# Special Meeting of Council Agenda

## 4.1 Planning Scheme Amendment C231 - Queens Parade - summary of submissions

Trim Record Number: D19/18175

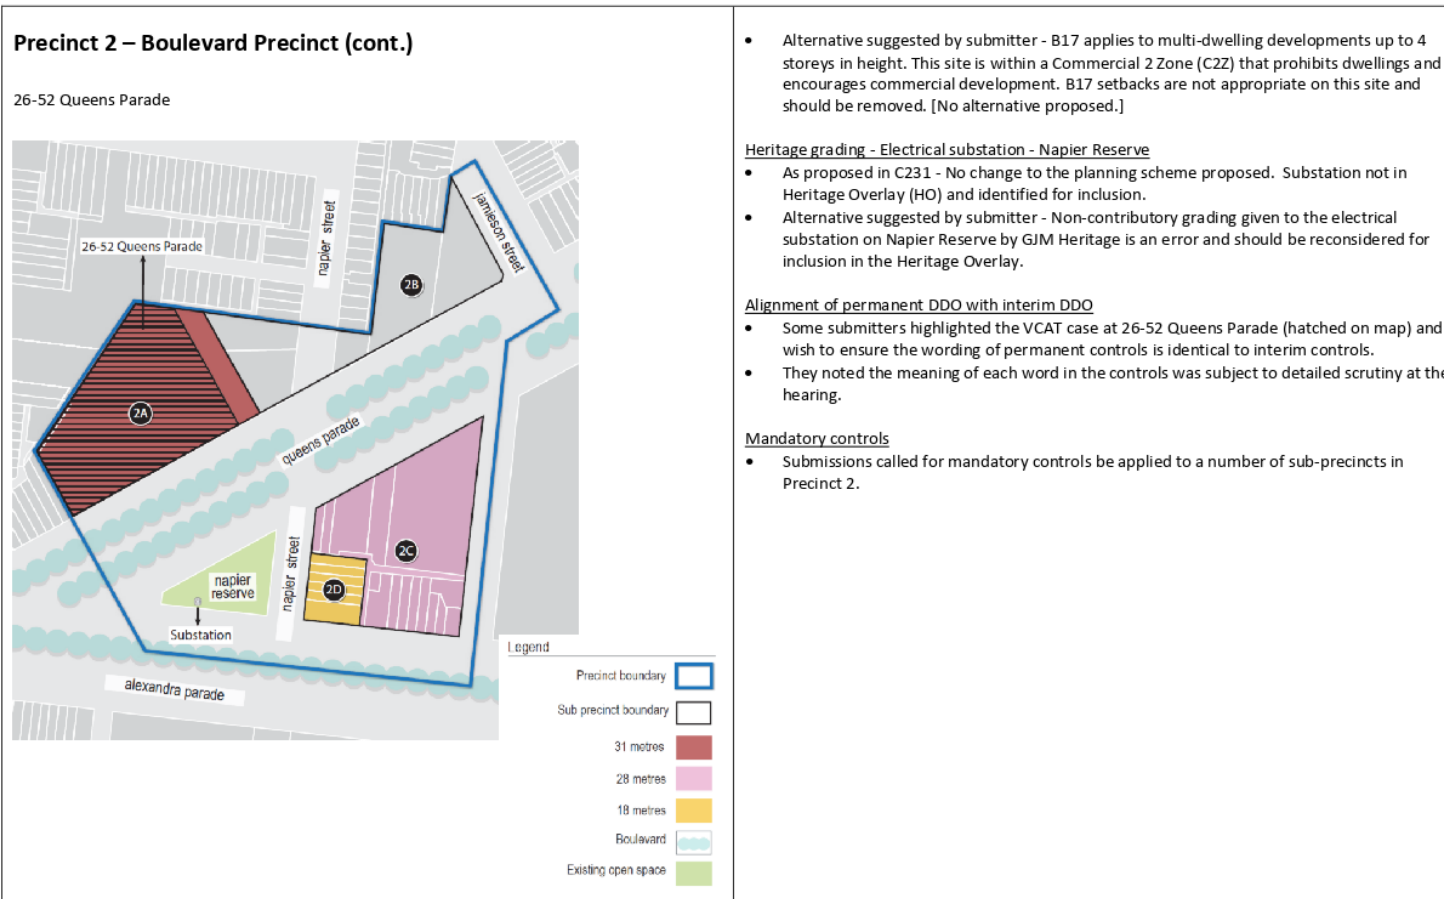
Proposed controls	Main issues raised
<p><b>Precinct 1 – Brunswick Street Precinct</b></p>  <p>NB – Precinct 1A is outside the area subject to Amendment C231.</p>	<p>Approximately 6 submitters raised issues specific to this precinct.</p> <p><u>Height</u> <u>Precinct 1B</u></p> <ul style="list-style-type: none"> <li>Proposed height in C231 – 9m (mandatory) adjoining 460 Brunswick Street (corner Queens Parade) and on land known as Lot 1 on Title Plan TP806921. 9m (preferred) applies elsewhere in the precinct.</li> <li>Alternative suggested by submitters: <ul style="list-style-type: none"> <li>No alternative height suggested. Submitters supported the proposed controls ie maximum mandatory 9m / 3 storey height but wanted a mandatory control across the precinct.</li> <li>See note on page 1 re multi-precinct submissions.</li> </ul> </li> </ul> <p><u>Overlooking</u> <u>Precinct 1A</u></p> <ul style="list-style-type: none"> <li>Precinct 1A is not part of the amendment (outside the DDO).</li> <li>Two submitters commented that the Aquila Building at 500 Brunswick Street (an apartment building of six storeys to the immediate north of Precinct 1B) is a prime example of failed planning controls, particularly in terms of overlooking.</li> </ul> <p><u>Mandatory controls</u></p> <ul style="list-style-type: none"> <li>Submitters supported mandatory height controls for Precinct 1.</li> </ul>

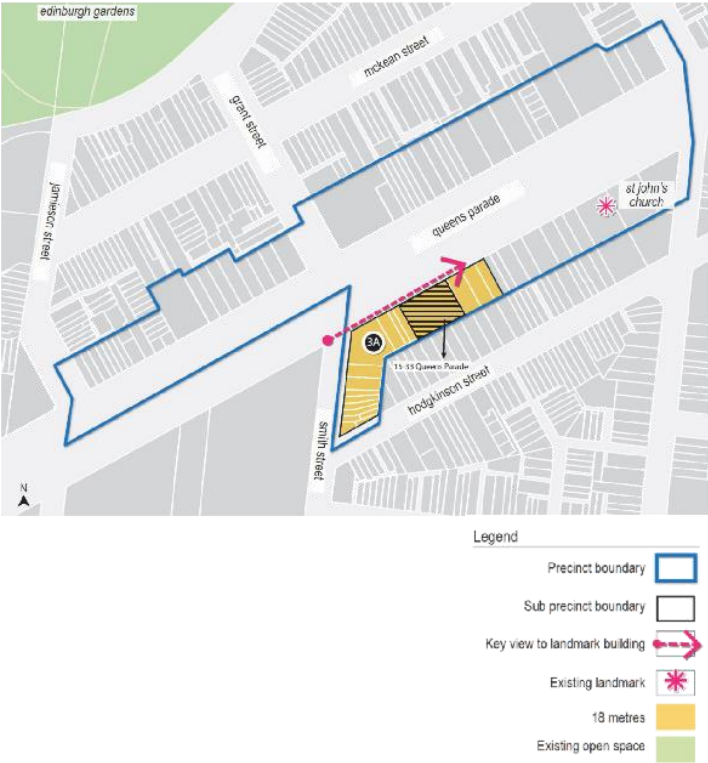
Proposed controls	Main issues raised
<p><b>Precinct 2 – Boulevard Precinct</b></p>  <p>Legend</p> <ul style="list-style-type: none"> <li>Precinct boundary</li> <li>Sub precinct boundary</li> <li>31 metres</li> <li>28 metres</li> <li>18 metres</li> <li>Boulevard</li> <li>Existing open space</li> </ul>	<p>Approximately 15 submitters made specific comments in relation to Precinct 2. [Noting other submitters referenced 26-52 Queens Parade as an example of a development site.]</p> <p><u>Height</u></p> <p><u>Precinct 2A</u></p> <ul style="list-style-type: none"> <li>Proposed height in C231 - 31m (mandatory)</li> <li>Alternative heights suggested by submitters: <ul style="list-style-type: none"> <li>Up to 18 metres / 5 storeys</li> <li>31m as recommended in the Hansen report but height limit to be mandatory.</li> </ul> </li> </ul> <p><u>Precinct 2B</u></p> <ul style="list-style-type: none"> <li>Proposed height in C231 - Land largely in MUZ and outside the proposed DDO. No height control applies in MUZ or is proposed in the amendment.</li> <li>Alternative height: <ul style="list-style-type: none"> <li>3 storey (9m) as recommended in the Hansen report but height limit to be mandatory.</li> </ul> </li> </ul> <p><u>Precinct 2C</u></p> <ul style="list-style-type: none"> <li>Proposed height in C231 - 28m (preferred)</li> <li>Alternative heights: <ul style="list-style-type: none"> <li>Maximum building height should be 8 storeys (as the recent approval of 34.8 metres demonstrates). [No height in metres was suggested.] Hansen's recommended 28.5 metres is too low as this is a Commercial 2 Zone (C2Z) and commercial developments need higher floor to ceiling heights.</li> <li>Other submitters supported the 28.5m height proposed by Hansen but submitted the height limit should be mandatory.</li> </ul> </li> </ul> <p><u>Precinct 2D</u></p> <ul style="list-style-type: none"> <li>Proposed height in C231 - 18m (preferred)</li> <li>Alternative height: <ul style="list-style-type: none"> <li>Supported the 18m height recommended in the Hansen Report (and in the amendment) but the height should be mandatory.</li> </ul> </li> </ul> <p>See note on page 1 re multi-precinct submissions.</p> <p><u>Side and rear setbacks</u></p> <p><u>Precinct 2C</u></p> <ul style="list-style-type: none"> <li>Proposed setback in C231 - Apply B17 side and rear setbacks from Res Code.</li> </ul> <p>Continued over page</p>

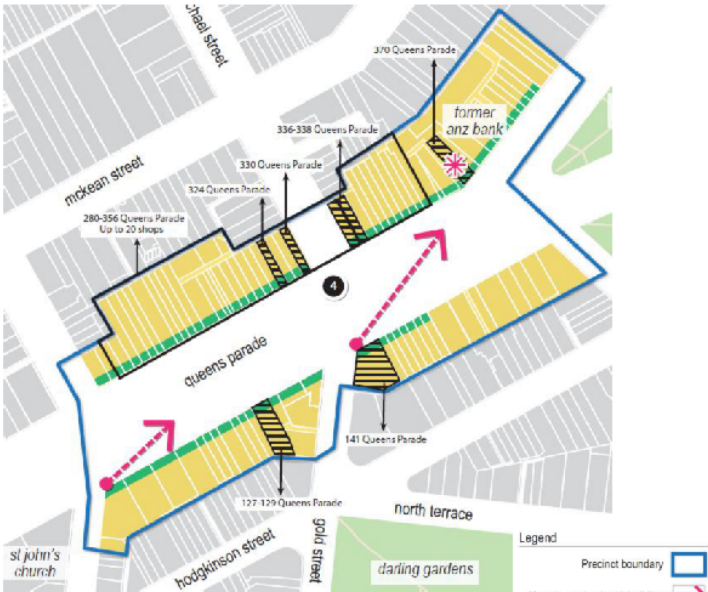
Proposed controls	Main issues raised
<p><b>Precinct 3 – St Johns Precinct</b></p>  <p>Legend</p> <ul style="list-style-type: none"> <li>Precinct boundary</li> <li>Sub precinct boundary</li> <li>Key view to landmark building</li> <li>Existing landmark</li> <li>18 metres</li> <li>Existing open space</li> </ul>	<p>Approximately 14 submitters made specific comments in relation to Precinct 3.</p> <p><u>Height</u></p> <p><u>Precinct 3A</u></p> <ul style="list-style-type: none"> <li>Proposed height in C231 - 18m (preferred) <ul style="list-style-type: none"> <li>Submissions commented 18m is too high and means that new development will dominate existing buildings and will not respect “the architectural form and qualities of heritage buildings and streetscapes”.</li> <li>Concern also expressed about the potential loss of the appreciation of the clear view to St John’s Church belfry and spire if taller development were approved. Views of St John’s should not be obstructed.</li> <li>Does not respect the low scale, fine grain subdivision pattern of existing development along Hodgkinson Street.</li> </ul> </li> <li>Alternative heights suggested by submitters: <ul style="list-style-type: none"> <li>3 storey maximum to protect the amenity of properties to the rear.</li> <li>A mandatory maximum of 4 storeys (12m).</li> <li>14m is a more suitable height than the proposed 18m.</li> </ul> </li> </ul> <p>See note on page 1 re multi-precinct submissions.</p> <p><u>Precinct 3B (remainder of precinct outside DDO area)</u></p> <ul style="list-style-type: none"> <li>Proposed height in C231 - No height proposed in C231. Land is in NRZ with a mandatory maximum height of 9m.</li> <li>Alternative height - Height limit to be mandatory.</li> </ul> <p><u>Street wall height</u></p> <ul style="list-style-type: none"> <li>Proposed height in C231 - 11m for 15-33 Queens Parade, 14m elsewhere in the precinct.</li> <li>Alternative suggested by submitters - 11m street wall height for the whole precinct was recommended by one submitter.</li> </ul> <p><u>Residential interfaces</u></p> <ul style="list-style-type: none"> <li>Proposed setback in C231 - 45° setback above 8m where there is a lane and above 5m where there is no lane. <ul style="list-style-type: none"> <li>Large number of submitters raised concerns about overlooking, overshadowing, solar access and building bulk. (Traffic and access are discussed below.)</li> <li>Only a narrow lane separates some adjoining residents from proposed taller development, others adjoin the Commercial 1 Zoned land directly.</li> <li>Hodgkinson Street dwellings have small rear yards which would be impacted by the taller development. Development of 18m will allow developers to profit at the expense of residents.</li> <li>Prioritising heritage on Queens Parade pushes bulk to the rear of the site.</li> </ul> </li> </ul>

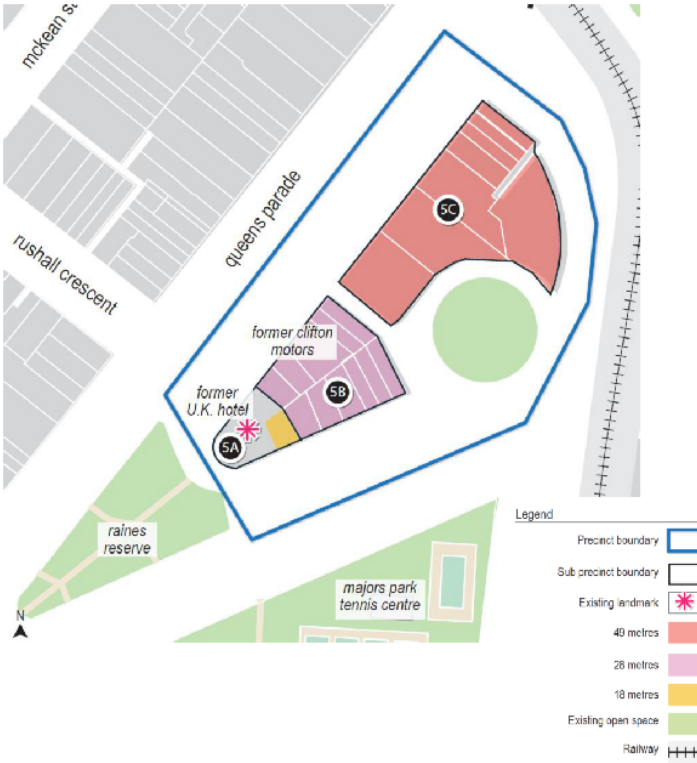
Proposed controls	Main issues raised
<p><b>Precinct 4 – Activity Centre Precinct</b></p>  <p>The map illustrates the layout of Precinct 4, an activity centre precinct. It shows a network of streets including Michael Street, McKean Street, Queens Parade, Hodgkinson Street, Gold Street, and North Terrace. Key landmarks such as St John's Church and the Former ANZ Bank are marked. The precinct boundary is outlined in blue. A legend identifies symbols for the precinct boundary, key views to landmark buildings, existing landmarks, significant heritage streetscapes, a 21.5m height limit, and existing open space. A pink arrow indicates a key view from the precinct towards the Former ANZ Bank.</p>	<p>The overwhelming majority of submissions were focussed on Precinct 4. Noting a number of submissions did not specifically reference 'Precinct 4' but mentioned the shopping strip and/or a proposed height of 6 storeys.</p> <p><u>Height</u></p> <ul style="list-style-type: none"> <li>Proposed height in C231 – 21.5m (mandatory) <ul style="list-style-type: none"> <li>One submitter supported the 6 storey height.</li> <li>The rest expressed strong feelings about the proposed height – a large majority said 6 storeys was too high. Eg “beyond the pale and intolerable.”</li> <li>6 storeys was an inappropriate scale of development in the shopping centre precinct.</li> <li>Impacts on the heritage significance of the Queens Parade streetscape and buildings as well as amenity impacts were raised (see comments below under Heritage).</li> </ul> </li> <li>Alternatives suggested by submitters: <ul style="list-style-type: none"> <li>Majority view was that 4 storeys was appropriate.</li> <li>However a significant minority suggested a 3 storey maximum.</li> <li>Other submissions wished to limit the height so that nothing could be visible above the parapet from the other side of the road.</li> <li>A small number of submissions reminded Council of its resolution of 22 November 2016 which called on the Minister for Planning to introduce interim controls to historic shopping streets with a maximum height of 11.5m.</li> <li>Specific concerns were also raised about the 1:1 visibility ratio (overall height to street wall height). Submitted a 1:1 ratio would allow an 18 metre height, yet the DDO specifies 21 metres (a ratio of 1.2:1).</li> </ul> </li> <li>A couple of submissions expressed concern about the visibility of services and lift overruns from surrounding streets</li> <li>A significant number of submissions expressed disappointment about changes in proposed heights over time, particularly: <ul style="list-style-type: none"> <li>The fact that consultants (Hansen) had initially recommended a 4 storey height in February 2017 (to support the interim controls introduced by Amendment C229)</li> <li>Hansen proposed 5 storeys in December 2017 in its Built Form Framework which informs Amendment 231</li> <li>Council chose to exhibit the amendment with a height of six storeys.</li> </ul> </li> </ul> <p>Continued over page</p>

Proposed controls	Main issues raised
<p><b>Precinct 4 – Activity Centre Precinct (cont.)</b></p> <p>127-129, 141, 280-356 (up to 20 shops), 324, 330, 336-338, 370 &amp; 390 Queens Parade</p>  <p><b>Legend</b></p> <ul style="list-style-type: none"> <li>Precinct boundary</li> <li>Key view to landmark building</li> <li>Existing landmark</li> <li>Significant heritage streetscape</li> <li>21.5 metres</li> <li>Existing open space</li> </ul>	<p><b>Mandatory controls</b></p> <ul style="list-style-type: none"> <li>The majority of submissions urged Council to introduce mandatory controls. Most sought mandatory building heights. Others sought minimum mandatory setbacks.</li> <li>Those in favour of mandatory controls felt that preferred height limits “are the source of much dispute and expensive litigation” and should be replaced by a mandatory limit.</li> </ul> <p><b>Upper level setbacks</b></p> <ul style="list-style-type: none"> <li>Proposed - 6m setback <ul style="list-style-type: none"> <li>Submissions referred to inadequate setbacks and feared facadism would result.</li> </ul> </li> <li>Alternatives: <ul style="list-style-type: none"> <li>Fewer submissions suggested an alternative setback compared to those who had a view on height.</li> <li>Alternatives included: <ul style="list-style-type: none"> <li>8 metres (as recommended by Hansen in February 2017)</li> <li>10 metres (Some that suggested 10m reminded Council of its resolution of 22 November 2016 – see height above)</li> <li>12 metres.</li> </ul> </li> </ul> </li> </ul> <p><b>Heritage</b></p> <ul style="list-style-type: none"> <li>Heritage was intrinsic and important to the character of the area. Submitters wanted to preserve the centre for future generations.</li> <li>A large majority of submissions mentioned how they valued the shopping centre and feared that tall development would diminish the heritage and obscure the vista of heritage parapets with clear sky behind.</li> <li>The issue of height was strongly tied to the loss of heritage values.</li> <li>Setbacks were often raised in the context of heritage as well.</li> <li>Maintaining view lines to the former ANZ Bank building was seen as an important part of the controls.</li> </ul> <p><b>Heritage grading - 127-129, 141, 280-356, 324, 330, 336-338, 370 &amp; 390 Queens Parade</b></p> <ul style="list-style-type: none"> <li>Proposed - No changes were proposed to the gradings of the above properties excepting 304, 312 &amp; 316 Queens Parade.</li> <li>Alternatives: <ul style="list-style-type: none"> <li>Approximately six submissions requested changes to the heritage grading for 127-129, 141, 280-356 (up to 20 shops), 324, 330, 336-338, 370 and 390 Queens Parade.</li> <li>Submitters were concerned that the existing grading was insufficient to provide the level of heritage protection the buildings warranted. They requested Council review the grading of the properties and include them as individually significant properties within the Heritage Overlay.</li> </ul> </li> </ul>
